Revision of ACM0001 to include a default grid electricity emission factor if electricity consumption is less than 15 GWh/yr
Call for inputs for DOE submissions of request for revisions of approved methodologies

Revision of ACM0010 to include the option to apply a default grid electricity emission factor for both project and baseline emissions if electricity consumption is less than 15 GWh/yr
Call for inputs for DOE submissions of request for revisions of approved methodologies

Revision of AM0021 to include GHG emissions related to the production of ammonia used for DeNO$_x$ unit within the project boundary
Call for inputs for DOE submissions of request for revisions of approved methodologies

Revision of AM0034 to extend the applicability to include catalytic reduction of N₂O inside ammonia oxidation burner of Caprolactam plants

Figure 1: The INVISTA Process of N₂O decomposition

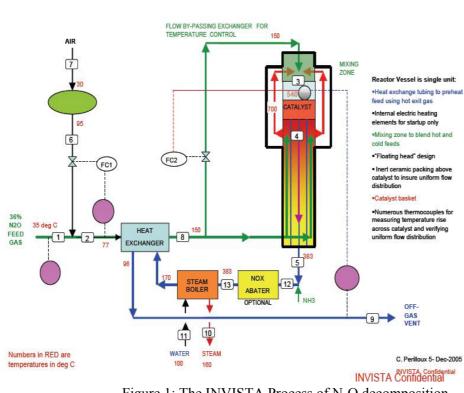
It is suggested that the same principle applies to AM0021 and that in case no DeNO$_x$ unit is installed prior to the start of the project activity then GHG emissions related to the production of ammonia used for NO$_x$ reduction should be considered as project emissions. Proposed text to be included in Project activity emissions are (reference is given to text in page 10 of AM0028):

***Ammonia Input to the destruction facility:***
In case an existing SCR DeNOx unit is already installed prior to the starting date of the project activity or has to be installed according to legal requirements, the project ammonia input will be considered equal to the ammonia input of the baseline scenario.

Should no SCR DeNOx unit be installed prior to the starting date of the project activity, project emissions related to the production of ammonia are considered as follows:

$$PE_{NH3,y} = Q_{NH3,y} \times EF_{NH3} \text{ (5)}$$

where:
$PE_{NH3,y}$ Project emissions related to ammonia input to destruction facility in year y (tCO$_2$e)
$Q_{NH3,y}$ Ammonia input to the destruction facility in year y (tNH$_3$)
EF_{NH3} GHG emissions factor for ammonia production (CO$_2$e/tNH$_3$)
Please note: Ammonia input for NO$_x$ emission reduction will not cause GHG emissions other than related to the production of ammonia.
A default factor of 2.14 tCO$_2$e/tNH$_3$ is suggested (GEMIS 4.2).
